To: T10 SAS Protocol and Phy Working Groups

From: Brian Day and William Petty

Subject: SAS-2.1 / SPL: 08-439 An Optical OOB Method

Figure 1 — OOB signal transmission

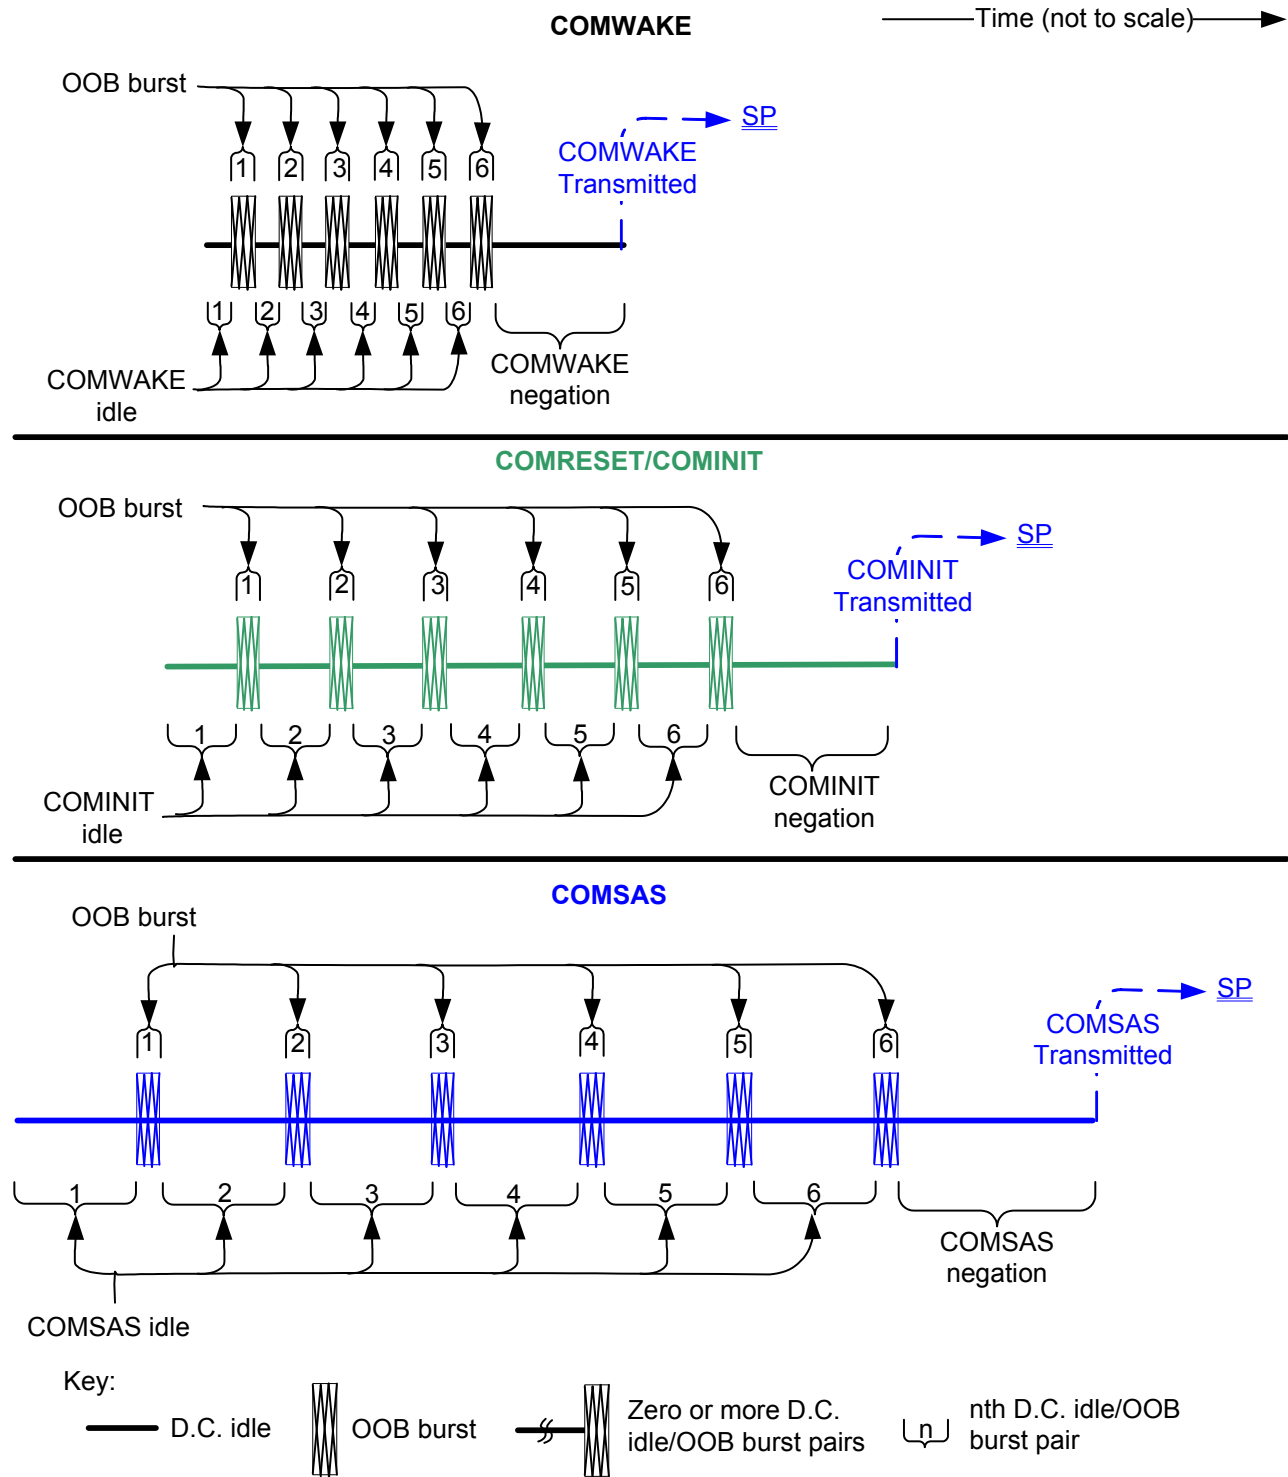
Editor's Note 1: [All figures in section 6 need to replace "D.C. Idle" with "OOB Idle"](#).

**Figure 2 — OOB signal detection**

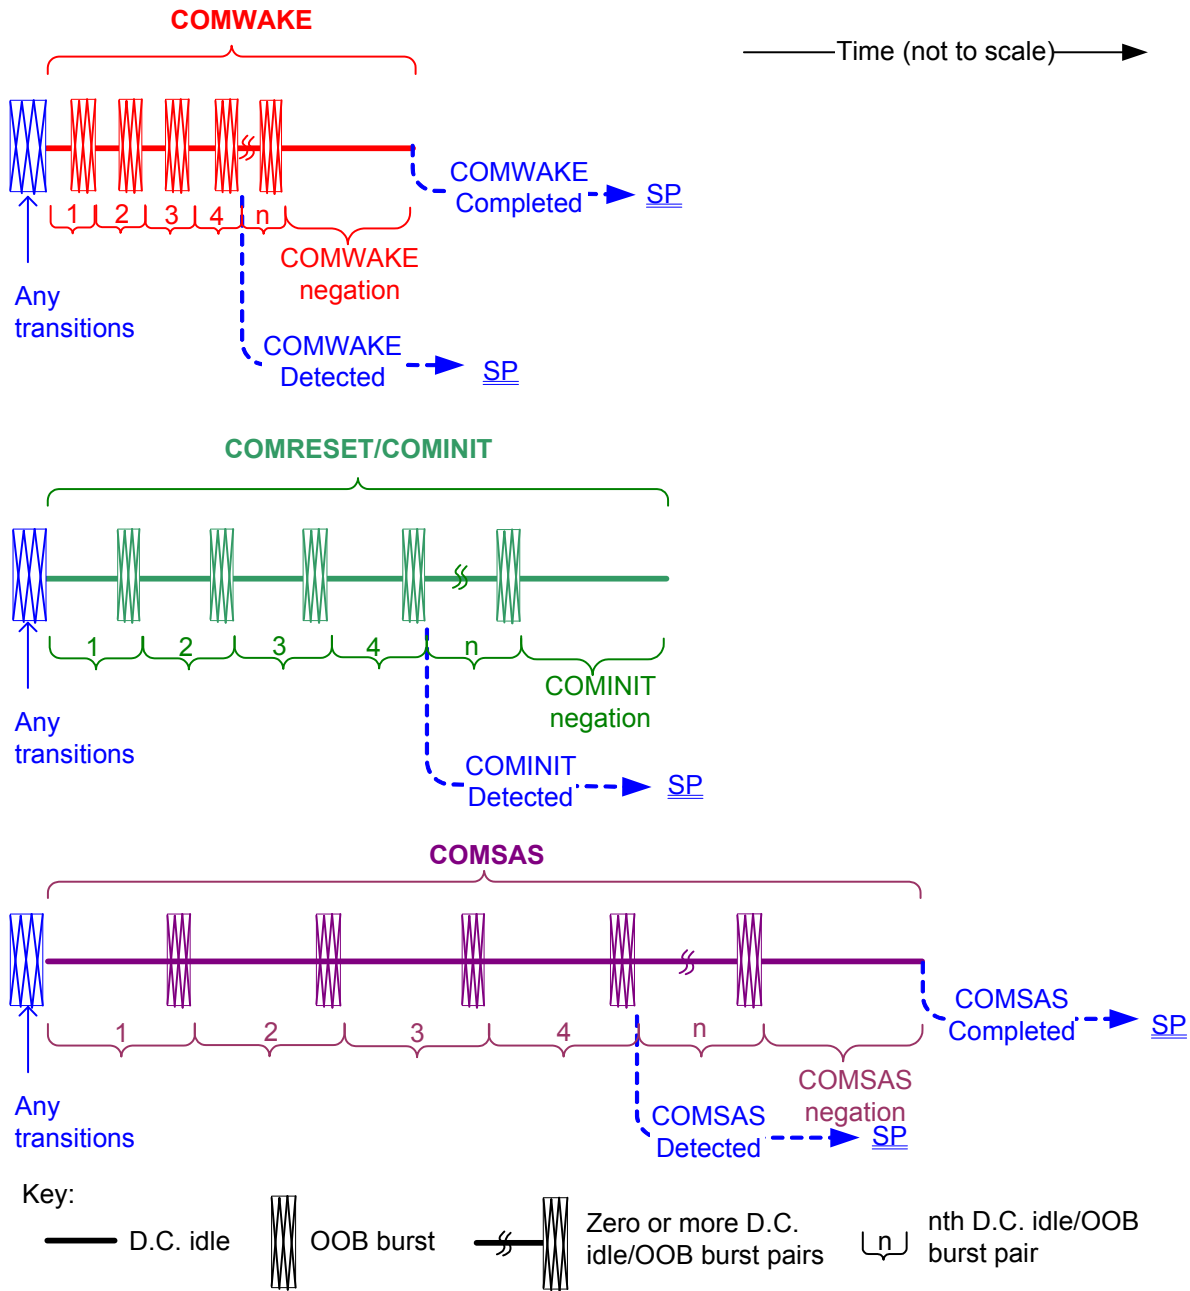
Editor's Note 2: Throughout section 6.7 and 6.8, replace all references of "D.C. idle" with "OOB idle" for the idle times to transmit OOB signals. Change all references of "D.C. idle" with "negation idle" for the idle time during the speed negotiation window during the RCDDT.
